Access Compliance Report

Public Rights-of-Way

(Curb Ramps)

Intersection ID: 52926	Main Street: WALTHAM_LN	Cross Street: EMORY_OAK_DR	Location: SW
ADA ID: B04DE2F56921	Ramp Type: Perp	Initial Pass/Fail: Pass	Overall Compliance: No
Codes/Mitigation Info/Possible Solution		Field Measurements/Component Compliance	
Severity Score: 10.25

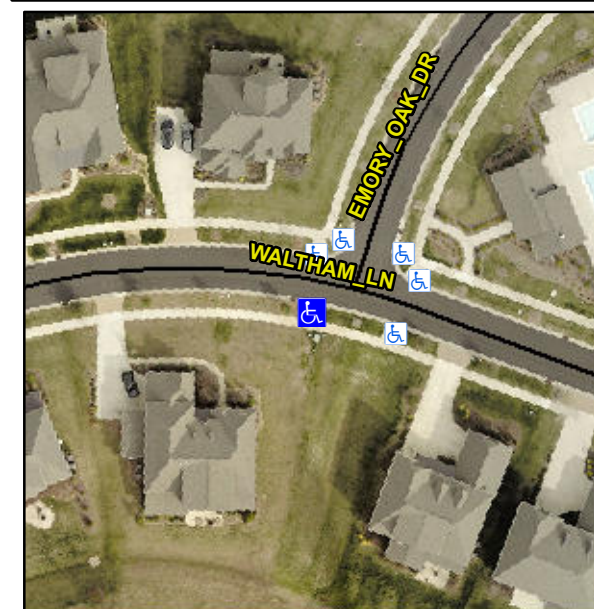
**Not Found, R304.5.3, R304.2.3,
R305.2, R304.5.4**

Compliance	Description	Data	Compliance	Description	Data
N/A	Ramp Length (in)	95.5	Yes	Ramp Slope (%)	6.2
Yes	Ramp Width (in)	60.0	No	Ramp XSlope (%)	2.2
N/A	Flare Type LT	Sloped	N/A	Flare Type RT	N/A
N/A	Flare Slope LT (%)	3.7	No	Flare Slope RT (%)	18.3
N/A	Flare Traversable LT?	Yes	N/A	Flare Traversable RT?	Yes
Yes	Landing Length (in)	61.0	Yes	DWS Provided?	Yes
Yes	Landing Width (in)	60.0	Yes	DWS Contrast?	Yes
Yes	Landing Slope (%)	1.6	Yes	DWS Length (in)	24.0
No	Landing X Slope (%)	2.1	Yes	DWS Full Width?	Yes
N/A	Landing Curb? (Y/N)	No	No	DWS Offset (in)	5.5
N/A	Shared Landing?	No			
Yes	Gutter Ponding?	No	No	Gutter Slope (%)	8.1
Yes	Gutter Lip Ht (in)	0.0	No	Gutter X Slope (%)	2.3
N/A	Painted X Walk1?	No	N/A	Painted X Walk2?	N/A
	X Walk 1 Direction	To N		X Walk 2 Direction	N/A
N/A	X Walk 1 Width (in)	N/A	N/A	X Walk 2 Width (in)	N/A
	X Walk 1 Slope (%)	2.6		X Walk 2 Slope (%)	N/A
	X Walk 1 X Slope (%)	1.6		X Walk 2 X Slope (%)	N/A

**Remove & Replace Entire Ramp.
Remove & Replace Gutter.**
